**ADDENDUM  
NO. 1**

**March 17, 2025**

**PORTER LAKES ELEMENTARY SCHOOL  
ADDITION, RENOVATIONS, AND RELATED WORK  
Hebron, IN 46341**

This Addendum consists of Pages ADD 1-1, Specification Section 00 34 10 – Responsible Bidding Practices, and attached Addendum No. 1 from Gibraltar Design, Inc. dated March 14, 2025 and consisting of 6 pages, Specification Section 07 41 13 – Aluminum Roofing and 28 drawings.

**4 BRACING ELEVATION - GRID E.C**  
1/4" = 1'-0"

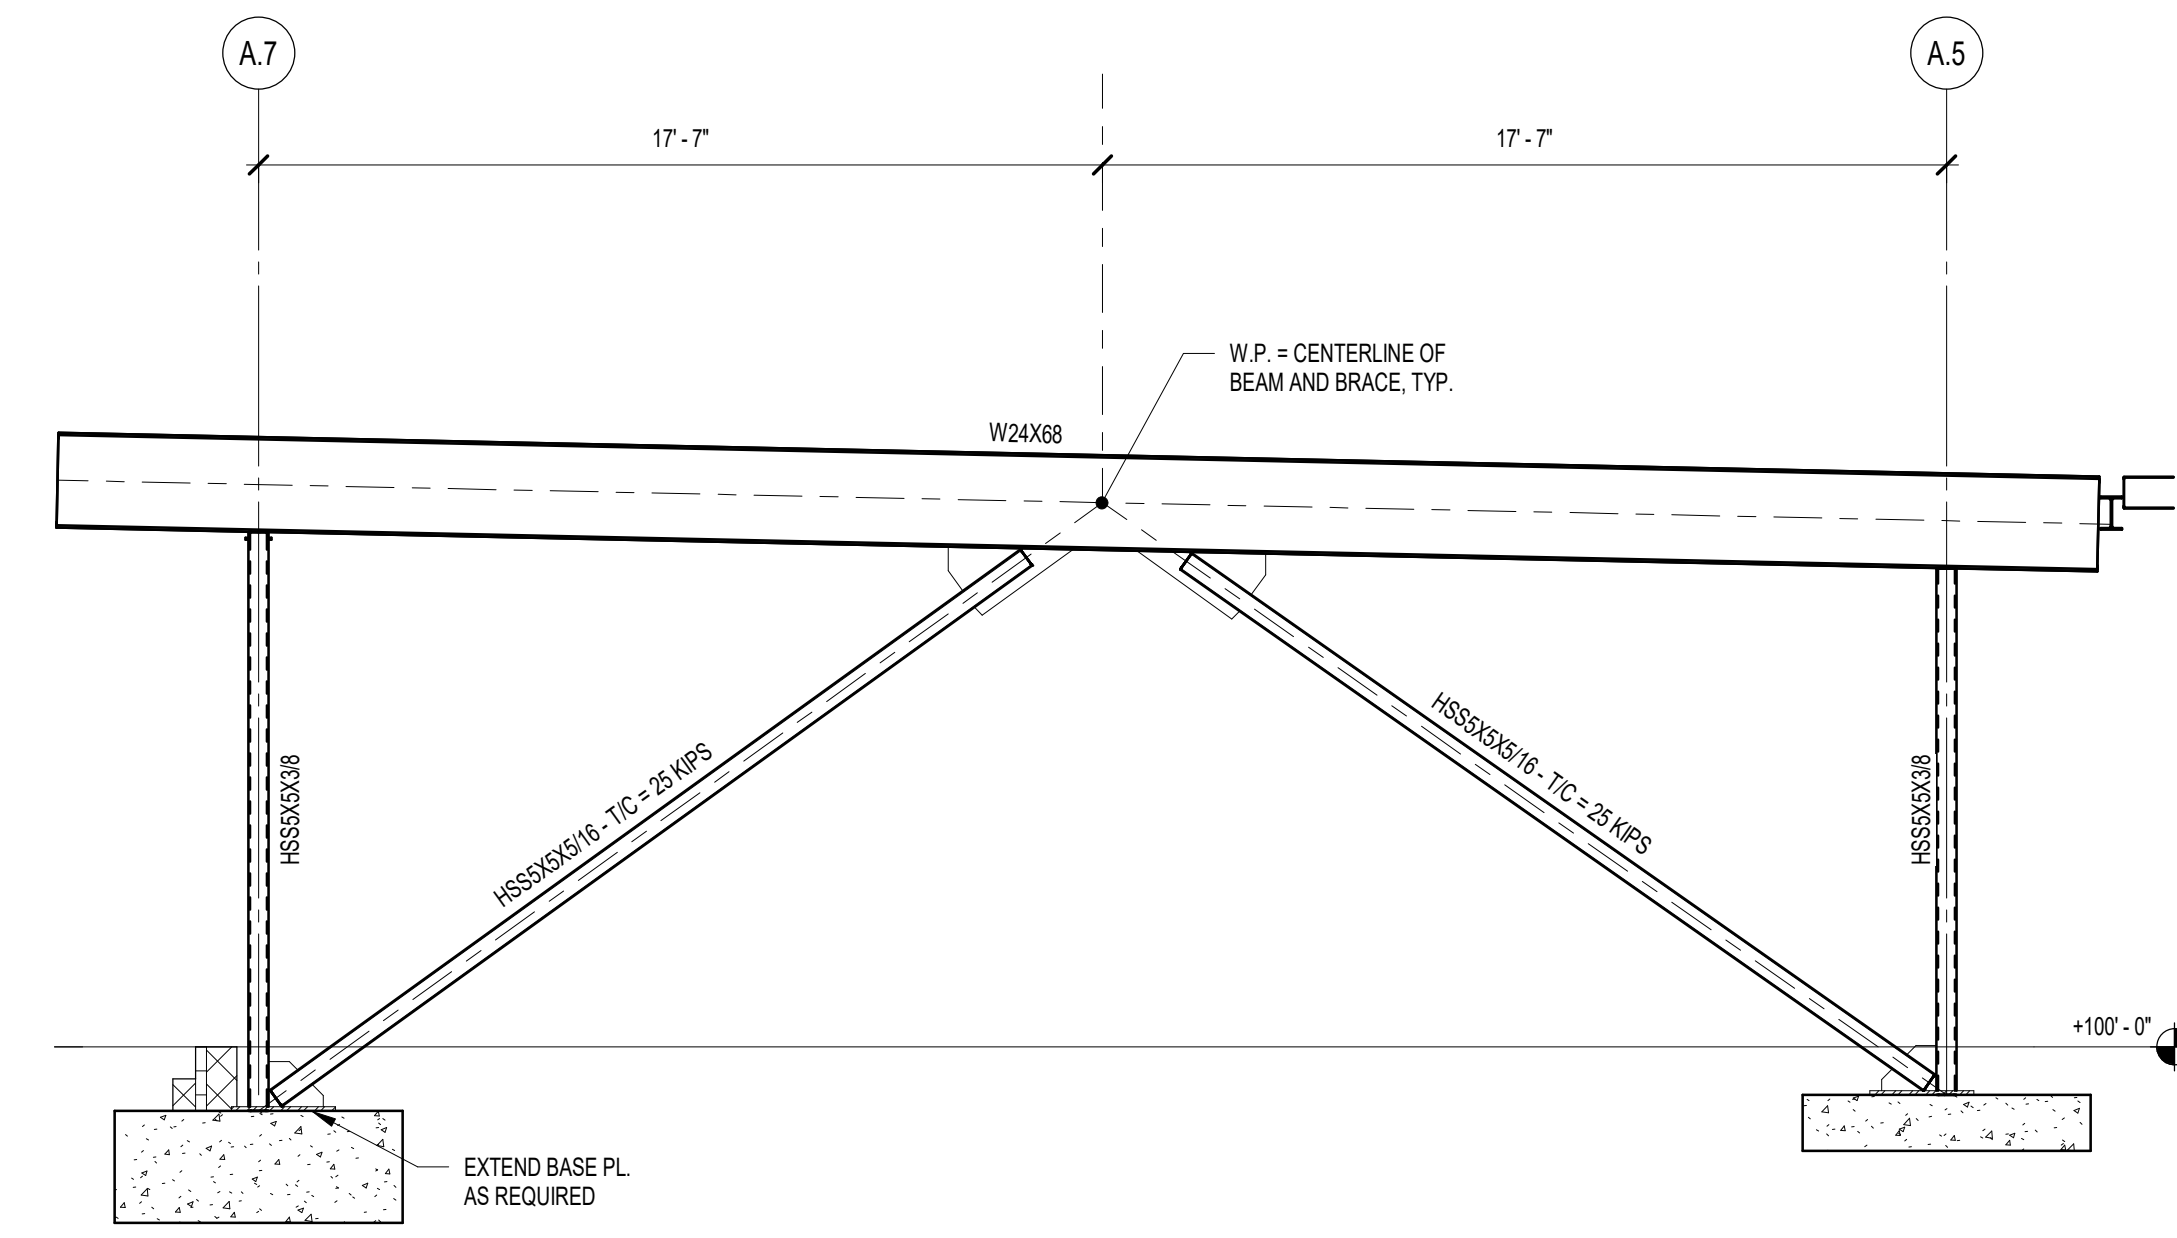
- A. Refer to revised, full-size drawing, included in this Addendum, for revisions.
  - 1. Concrete Piers Modified

**14** FRAMING SECTION  
3/4" = 1'-0"

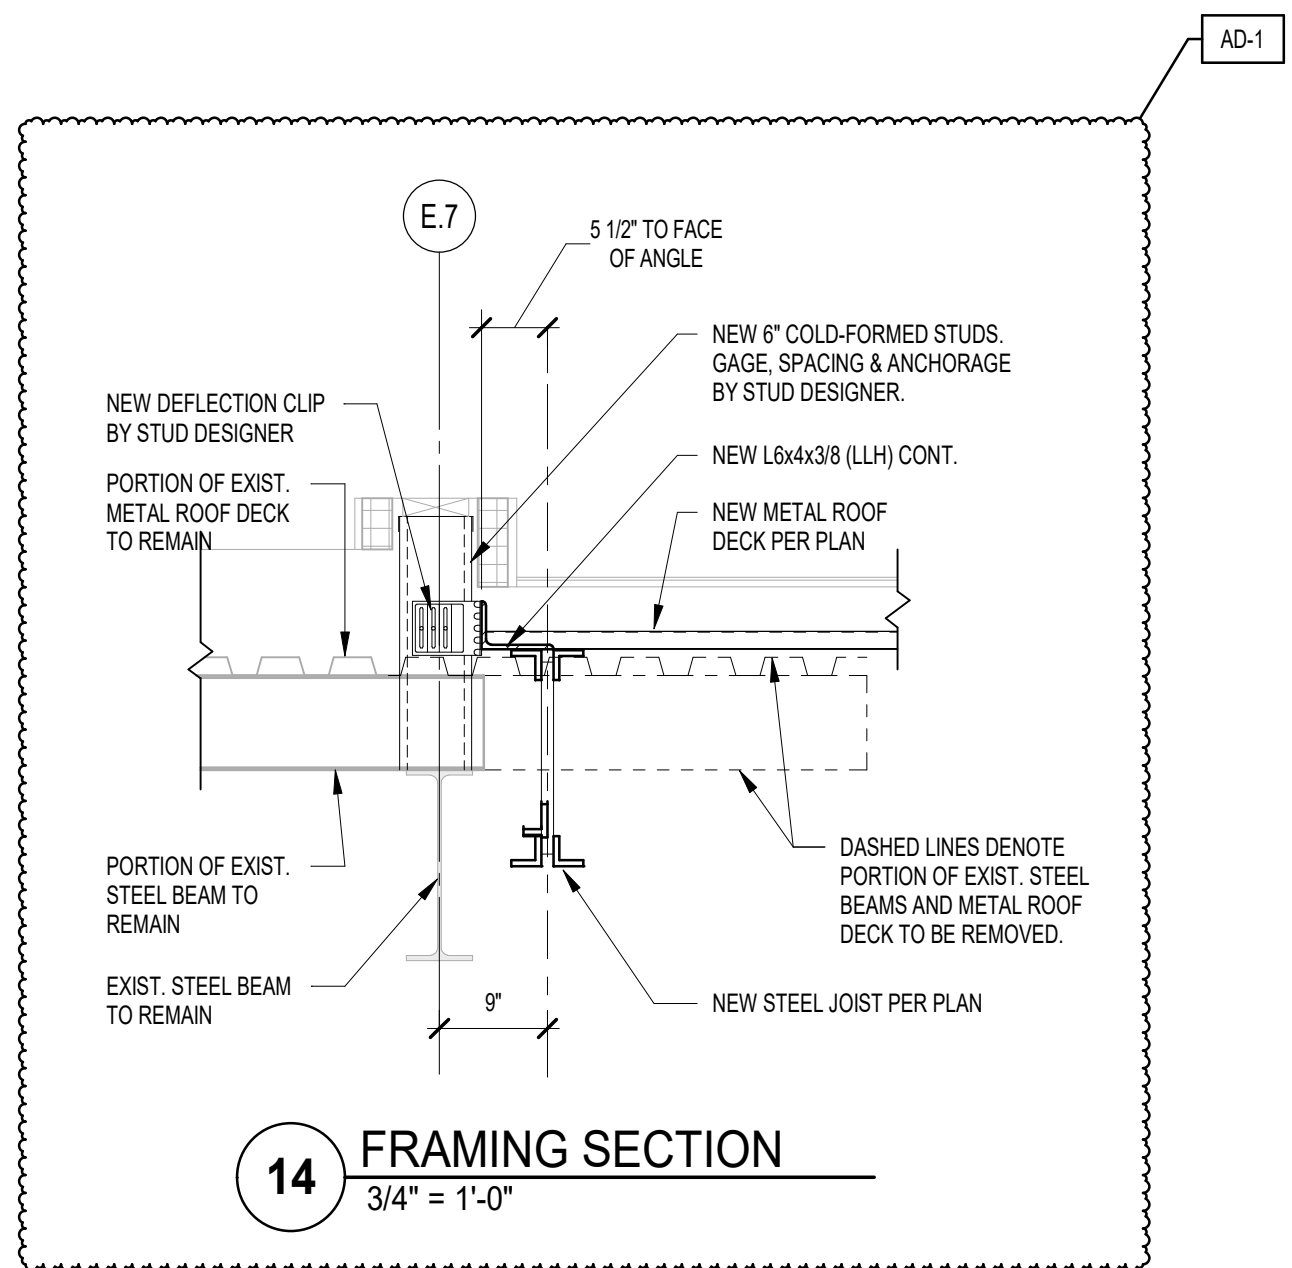
- A. Refer to revised, full-size drawing, included in this Addendum, for revisions.
  - 1. Section 14 Added

PROJECT: Porter Lakes Elementary School Addition, Renovations and Related Work  
SHEET: S-413

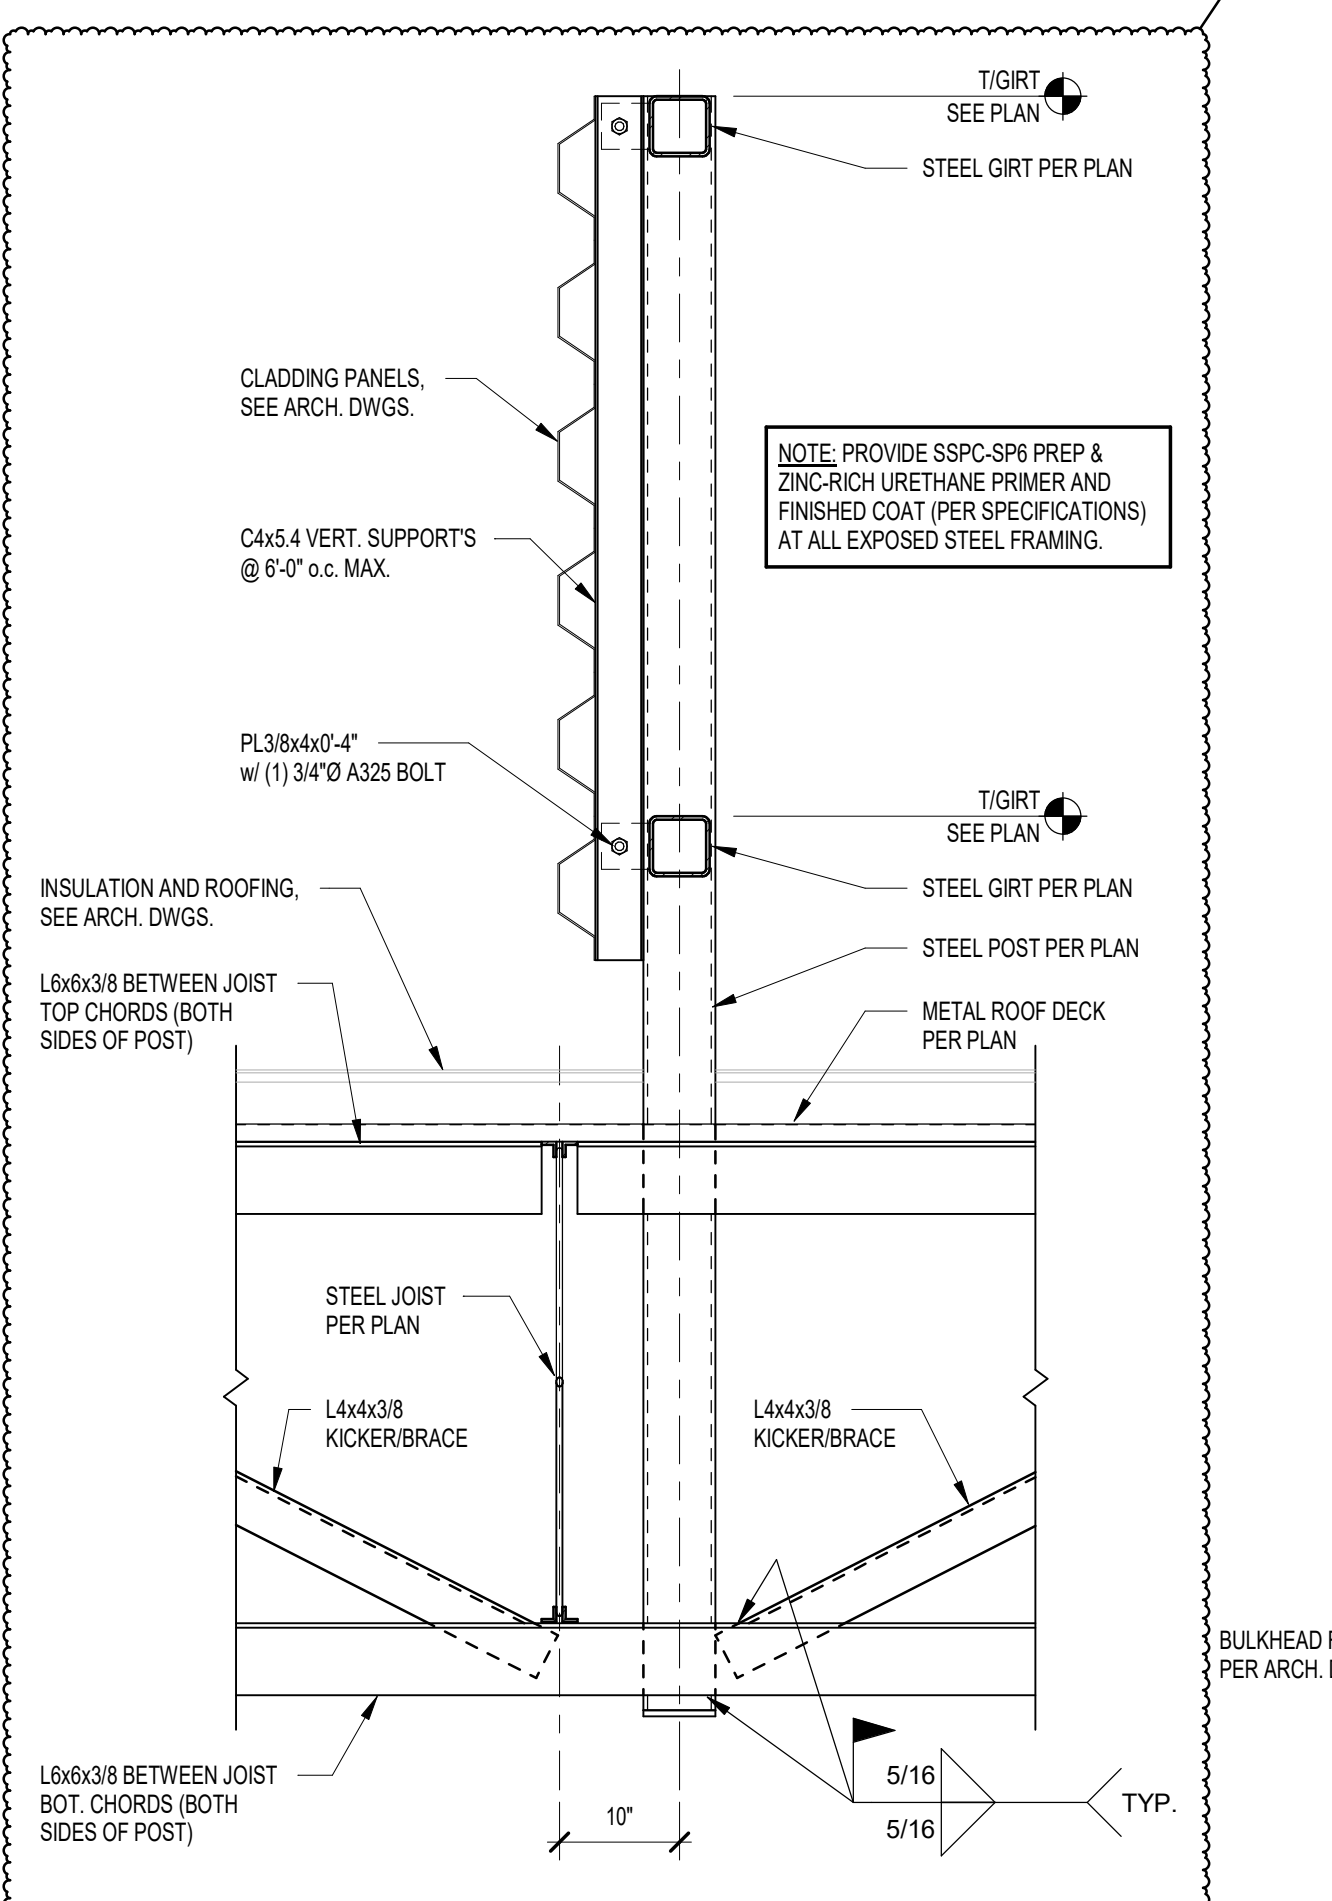
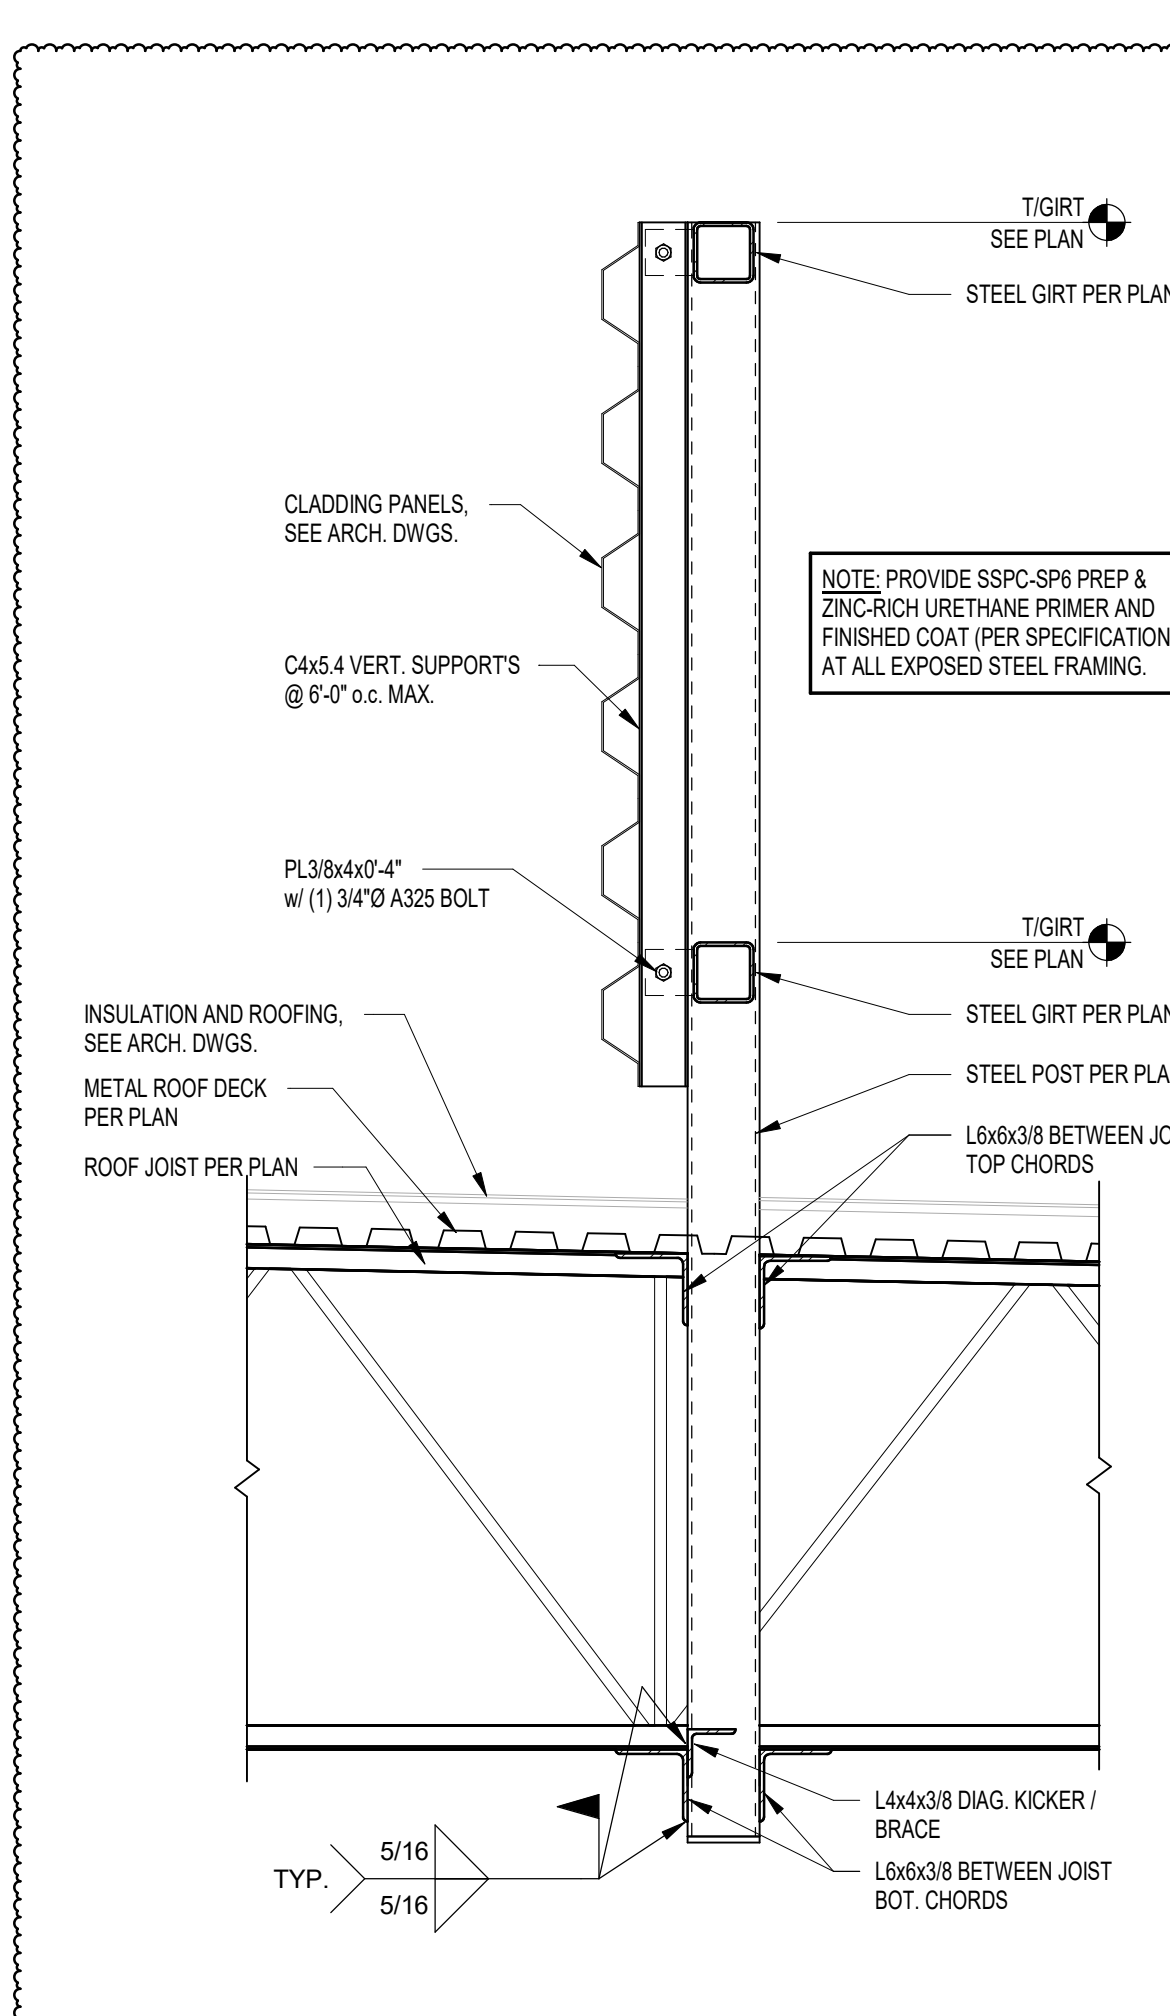
- A. Refer to revised, full-size drawing, included in this Addendum, for revisions.
  - 1. Sections 10 & 11 Added
